## Proposal for amendments to Regulation No. 13 (Heavy vehicle braking)

The text reproduced below was prepared by the experts of the informal working group ACV to be inserted into Regulation No. 13. This is to produce:

**Figure A: Point-to-point connection ECU Tractor (1) and ECU Trailer (9) when Fifth Wheel is closed**

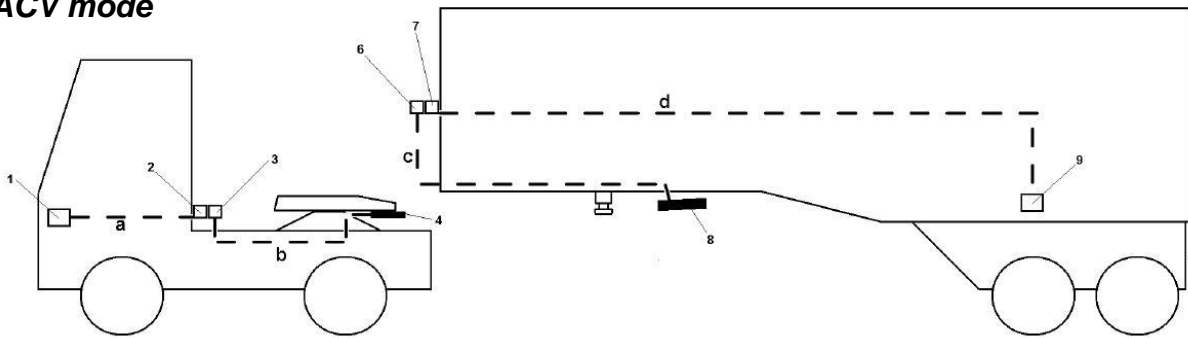
The active connection shall not have any bypasses or dead ends. (For example see Annex 21, Figure A to D) {Figure 4 ISO7638}

**ACV mode: No helix cables installed, Connection 3 to 6 when 4 and 8 connected (i.e. fifth wheel coupled)**

**Figure B: Point-to-point connection ECU Tractor (1) and ECU Trailer (9) when Fifth Wheel is closed**

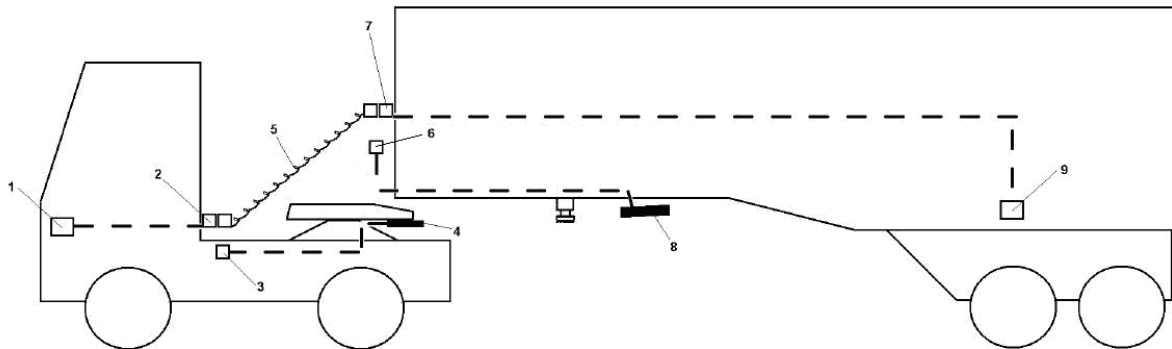
**Manual mode: Helix cables installed, Connection 3 to 6 and 4 and 8 are all offline (passive)**

**Figure C: Point-to-point connection ECU Tractor (1) and ECU Trailer (9) when Fifth Wheel is closed  
Helix cables installed, Line 3 to 4 offline**

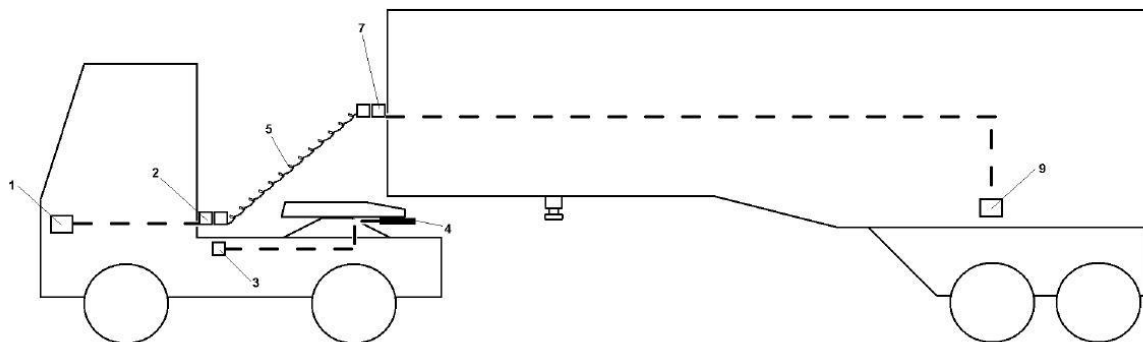
**Manual mode A (only the truck ACV equipped)**

**Figure D: Point-to-point connection ECU Tractor (1) and ECU Trailer (9) when Fifth Wheel is closed  
Helix cables installed, Line 6 to 8 offline**

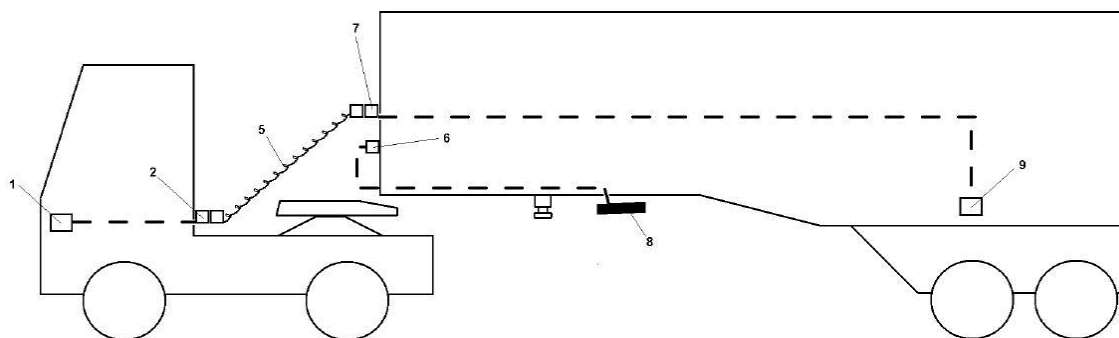
**Manual mode B (only the trailer ACV equipped)**
